## CUSTOMER INFORMATION

### COMPLAINTS ON EVO ENGINE SERIES

## 2) EVO CON ROD

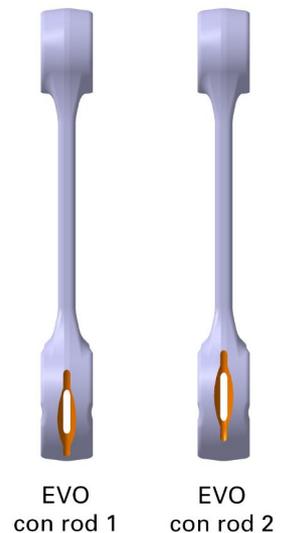
With the beginning of the racing season we have received complaints of failed evo 1 con rods.

These con rod failures have been analyzed and out of this the design of the evo 1 con rod has been slightly modified (= evo 2 con rod). This modification has significantly improved the durability of the con rod regarding the failures occurred on the market with evo 1 con rods.

As of following engine serial numbers the new evo 2 con rod is fitted as original equipment.

8398340 (125 Micro MAX evo, 125 Junior MAX evo, 125 MAX evo)

8382455 (125 MAX DD2 evo)

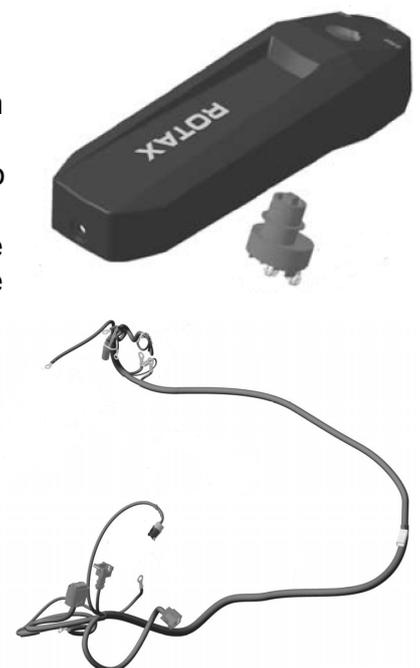
The claimed OFF/ON/START switches have failed due to an internal contact failure.

The technical design of the internal contact has been modified to ensure a faultless function.

A failure of the OFF/ON/START switch is covered under the regular Rotax manufacturer's warranty. A failed switch will be replaced by a switch with improved design.

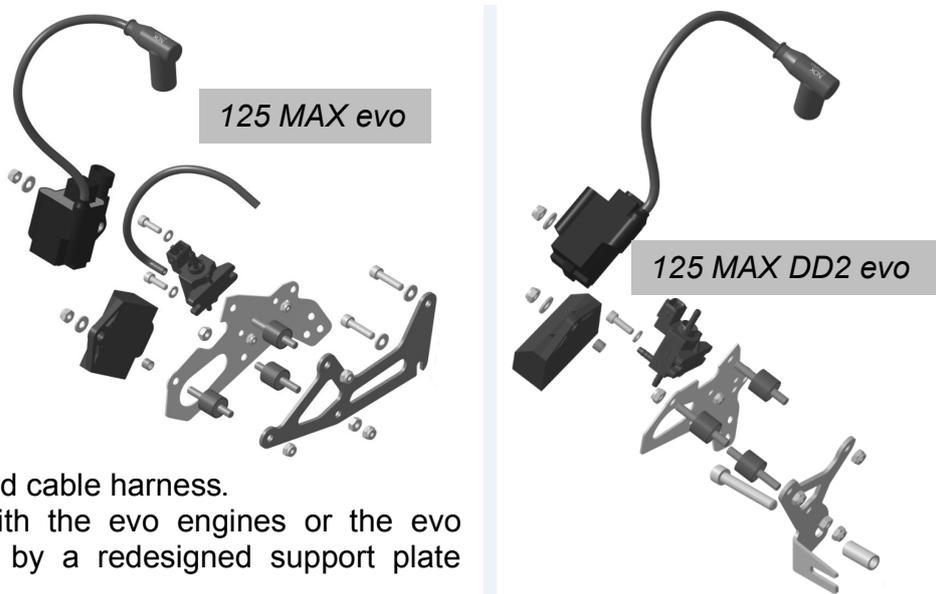
The claimed cable harnesses showed either broken connectors (ground wire, starter relay) or internal contact failures in connectors.

The vibration of the electrical components (ECU, ignition coil, magnet valve), caused by engine and vehicle vibrations, can have a negative impact on the durability of

the cable harness (depending on the installation of the cable harness in the kart).  
The cable harness has been modified in the critical areas to ensure durability and faultless function.

To minimize the vibration level of the electrical components BRP-Rotax will initiate an exchange campaign for the support plate which carries the ECU, ignition coil and magnet valve in combination with the improved cable harness.

The support plate supplied with the evo engines or the evo upgrade kits will be replaced by a redesigned support plate system (see illustrations).
